PARADISE DAM

FLOOD EVENT OF JANUARY TO MARCH 2013

REVIEW OF DAM SAFETY MANAGEMENT ACTIONS

REPORT FOR THE OFFICE OF WATER REGULATION

Figure 7 – Progression of Scour at Kariba Dam

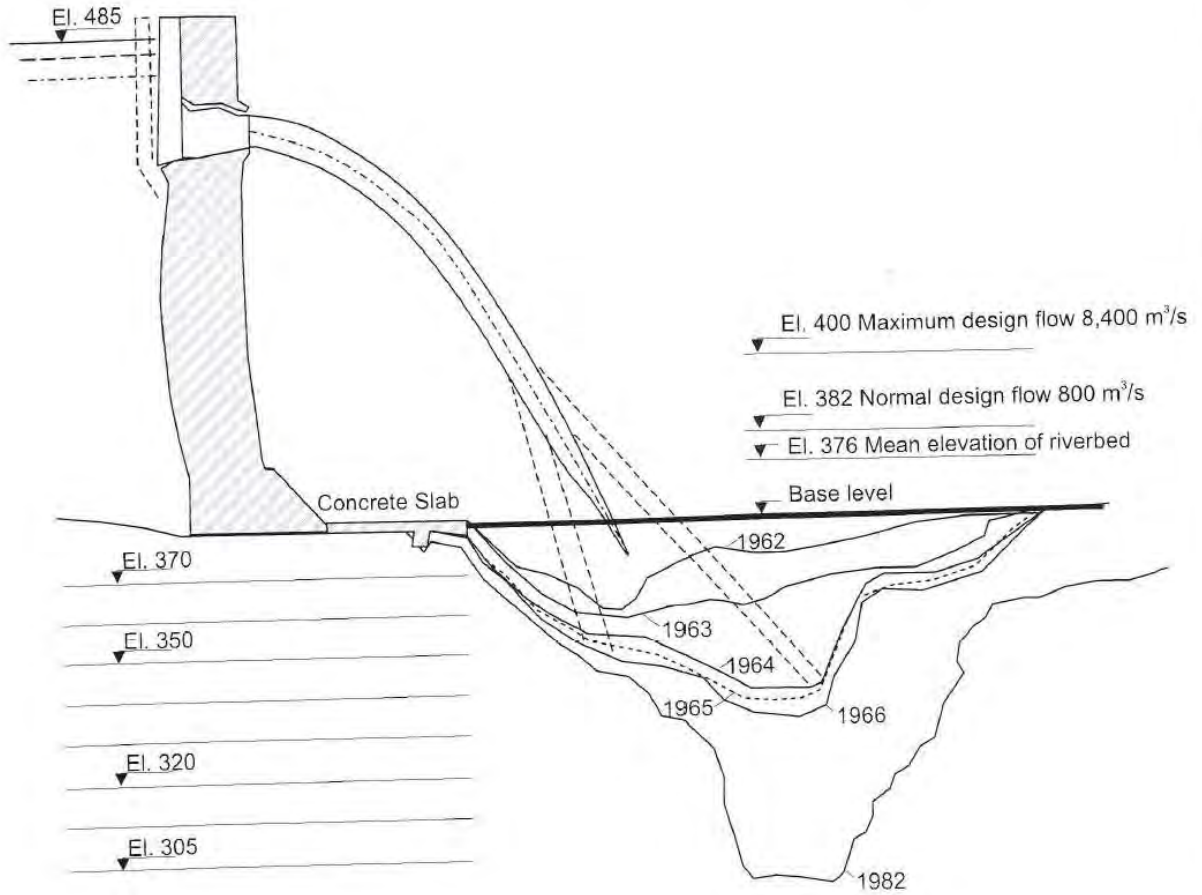
2. The rock in the energy dissipation zone is susceptible to deep scour – inspection after the flood revealed major rock scour. There are some points to be made about rock scour in the energy dissipation zones of dams. Firstly, experience shows that major rock scour in a large flood is not necessarily the end of the scour process. The classic demonstration of this reality is the case of Kariba Dam on the Zimbabwe/Zambia border (Bollaert 2005). In that case scour continued from successive floods over decades, eventually leading to a scour hole over 80m deep. **Figure 7** from CBDB (2002) shows the progression. Conditions at Paradise Dam are quite different but the possibility of further scour cannot be ruled out on the evidence available at this stage. Secondly, experience of scour at large dams is highly variable for reasons which are not immediately obvious. Because of large flows in its rivers, Brazil offers instructive lessons on rock scour at dams (CBDB 2002). Foz do Areia and Salto Santiago dams on the Iguacu River and Machadinho and Ita Dams on the Uruguay River are all within the one geologic province of more or less horizontal basalt flows. All four dams have experienced large floods with comparable peak discharges in the order of 10,000m³/s to 19,000m³/s and comparable energy dissipation heads in the range of 90m to 130m. Yet Ita and Machadinho Dams experienced major rock scour with up to 200,000m³ of fresh rock being removed whilst the experience at Salto Santiago and Foz do Areia Dams was negligible rock scour. When these dams are examined in more detail it becomes clear that engineering judgment is a poor guide to the likelihood of rock scour and that account needs to be taken of detail metrics of unit power, stress relief factors, rock joint spacing, orientation and cementation among other factors. This reality points to the need to apply rock scour estimation methodologies such as those developed by Annandale and separately by Bollaert as an aid to judgment.

Figure 9 – Probability of Failure versus a Safety Factor

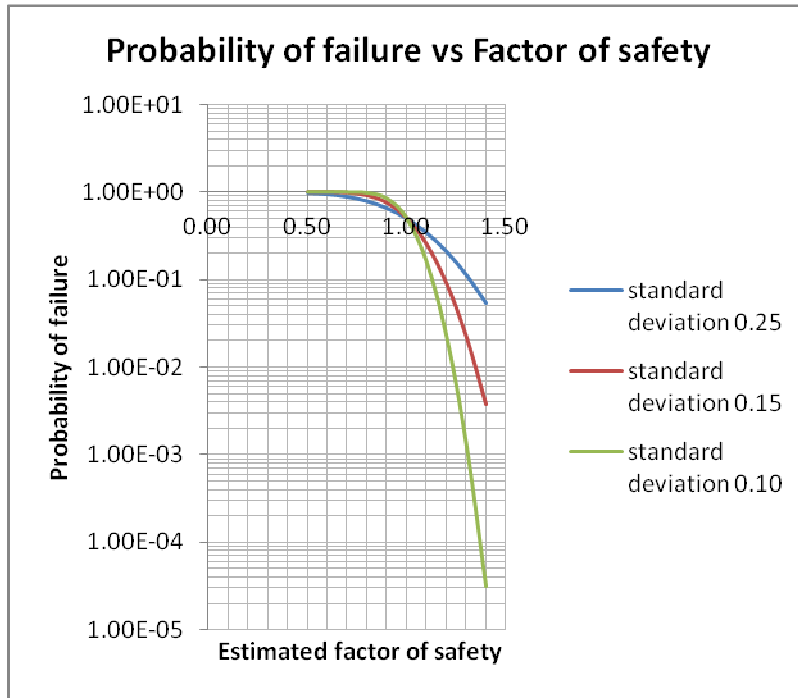
Analysts should not rely on **Figure 9** but should consult authoritative texts on *reliability analysis* and make their own assessments. A brief treatment of the concept can be found at pages 339 to 342 of Hartford and Baecher (2004).
